Consultation Record

Project Title	Pear Tree Solar Farm
---------------	----------------------

Meeting Title	Hydraulic Modelling Discussion
---------------	--------------------------------

SECTION 42 OF THE PLANNING ACT 2008: CONSULTATION ON PROPOSED APPLICATION FOR DEVELOPMENT CONSENT.

Figure 1: Locations on the River Hull which intersect the red line boundary for the site where breaches are not proposed.

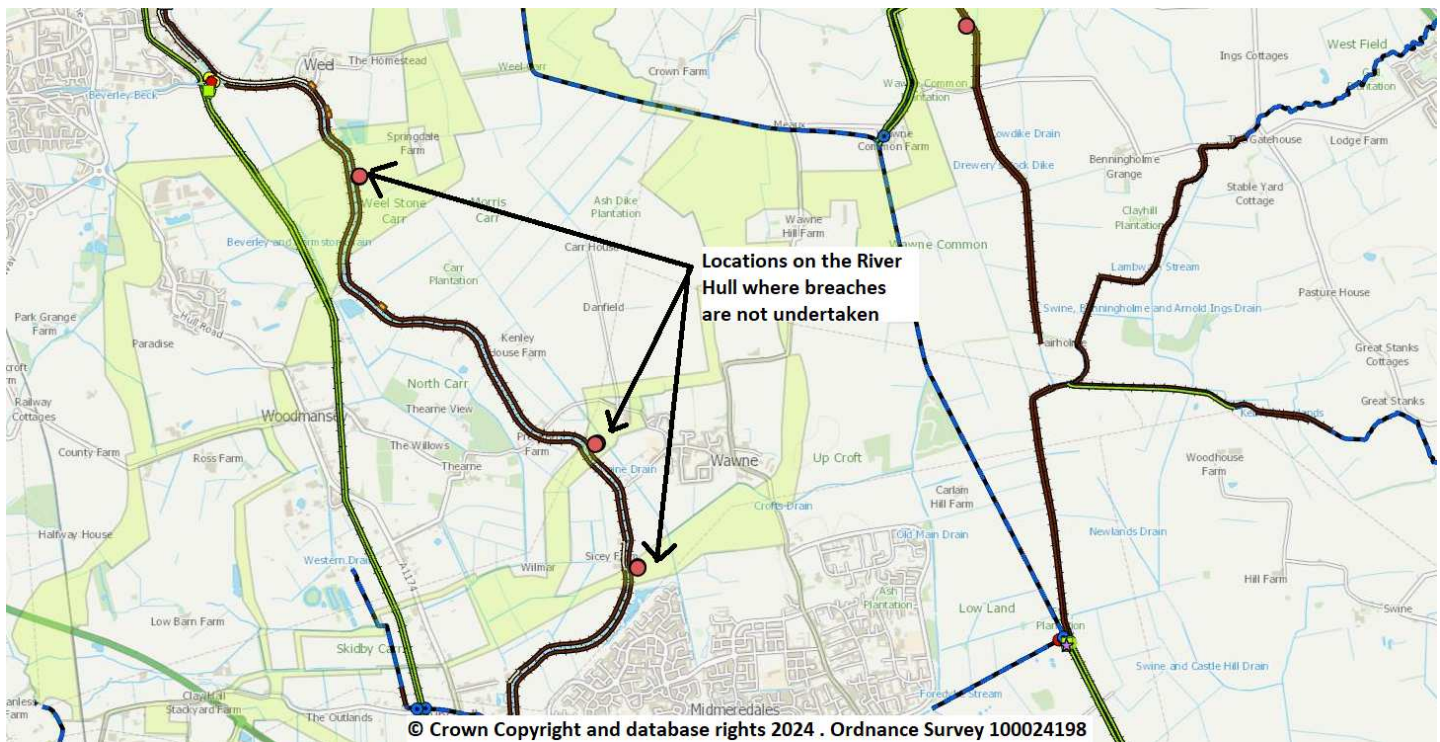
What was the rationale for not undertaking a breach at east 506700 north 438725, east 508280 north 436920, and east 508565 north 436090 on the left and right bank of the River Hull (figure 1 below)? Is this because these are relatively low risk areas for cable routing?
